ADDENDUM NO. 1

PROJECT NAME: Campus Rec Roof Replacement
UNL PROJECT NUMBER: C000P005
UNL INVITATION NUMBER: 2330-14-7200

DATE OF ISSUANCE: Tuesday, March 18, 2014
DATE OF BID OPENING: Tuesday, March 25, 2014 @ 2:00 P.M.

SECT.@ EX. SKYLIGHT (DEMO)

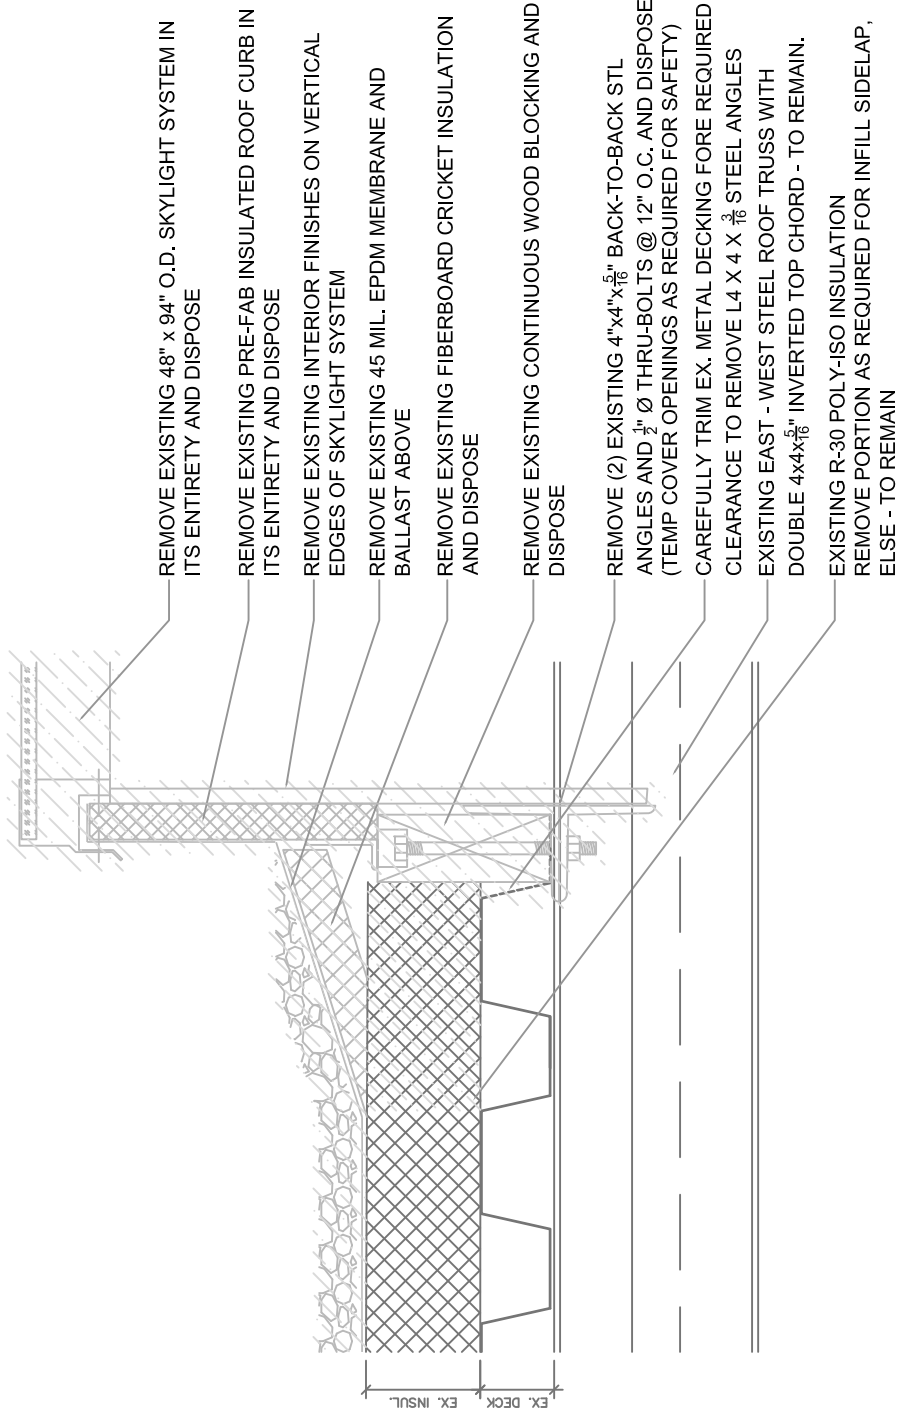
1. QUESTION How do we get the steel L4" x 4" x 3/16" steel angles out from above?

1. Add the following leader & note:
"Carefully trim existing metal decking for required clearance to remove L4" x 4" x 3/16" back to back STL angles"

RESPONSE: Trim the existing 20ga. metal decking as required at over-lap of decking at stl angles. Minimum of 6" bearing lap is required at existing metal deck to roof truss connection.
Break existing welds at Stl angles to roof truss top chord as required to remove.
